## **MAGGIE'S SNOW ROAD SUBDIVISION**

The purpose of this application is to subdivide an existing lot into two lots.

## MAGGIE'S SNOW ROAD SUBDIVISION

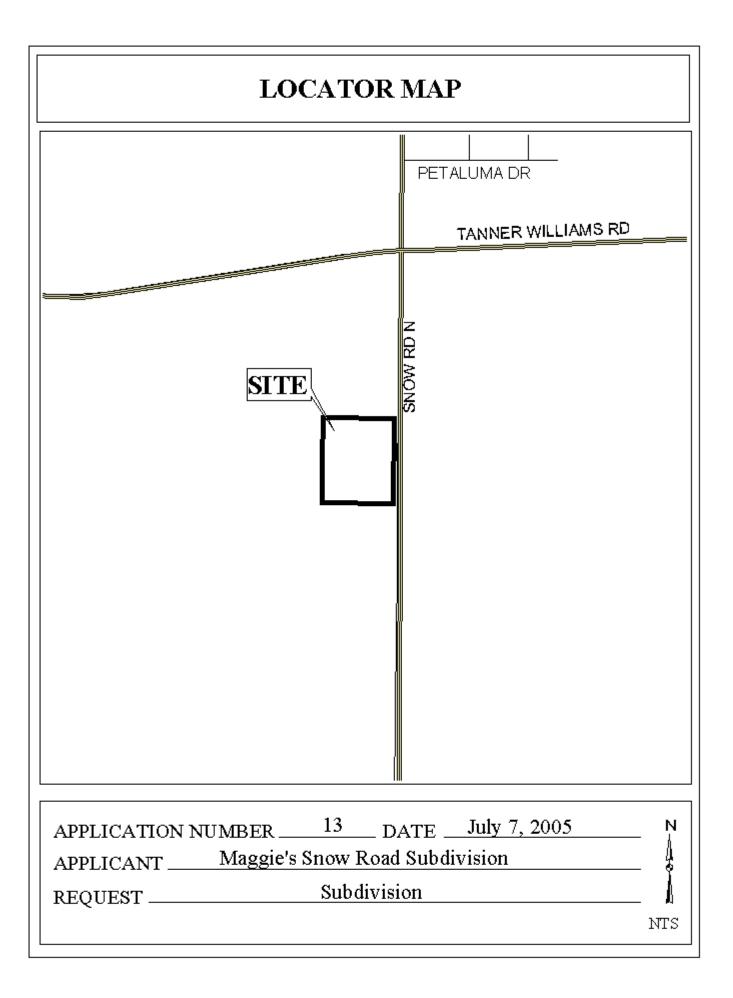
<u>Engineering Comments:</u> Must comply with the Mobile County Flood Damage Prevention Ordinance.

The site fronts Snow Road, a planned major street, which has an existing right-of-way of 90-feet; the Major Street Plan requires a 100-foot right-of-way. However, the plat submitted indicates that the lots appear to have dedication of the additional right-of-way; therefore in compliance. Additionally, as a means of access management, the placement of a note on the final plat stating that Lot 1 is limited to one curb cut and Lot 2 is limited to two curb cuts to Snow Road, with the location, size, and design to be approved by County Engineering, should be required.

This site is located in the County, thus a note should be placed on the final plat stating that any lots which are developed commercially and adjoin residentially developed property must provide a buffer, in compliance with Section V.A.7. of the Subdivision Regulations.

The plat meets the minimum requirements of the Subdivision Regulations and is recommended for Tentative Approval subject to the following conditions: 1) the placement of a note on the final plat stating that Lot 1 limited to one curb cut and Lot 2 is limited to two curb cuts to Snow Road, with the location, size, and design to be approved by County Engineering; and 2) the placement of a note on the final plat stating that any lots which are developed commercially and adjoin residentially developed property must provide a buffer, in compliance with Section V.A.7. of the Subdivision Regulations.
